PACKARD MOTOR CAR COMPANY

Counselor

JULY, 1952

New Universal Joint Dust Cover Kit Installation Instructions

Fig. 3

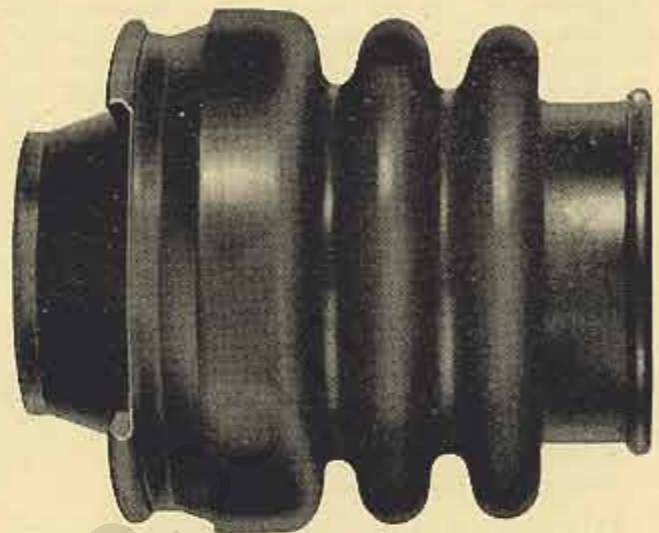
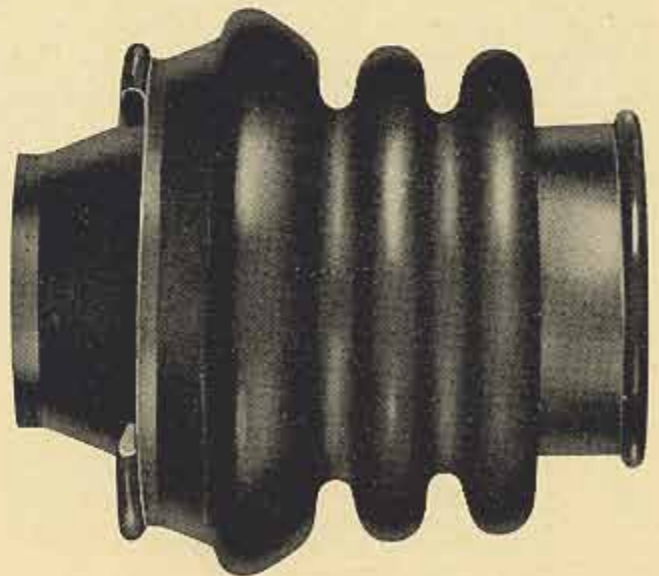
Figure 3 illustrates the dust cover that is supplied in the kit which can be installed through the body (note flat surface at the larger diameter).

Figure 4 illustrates the dust cover that is used in production and cannot be installed through the body.

The new universal joint dust cover kit, Part Number 436426, which obsoletes for service Parts Numbers 436103 and 436102, can be installed without removing the universal joint pin.
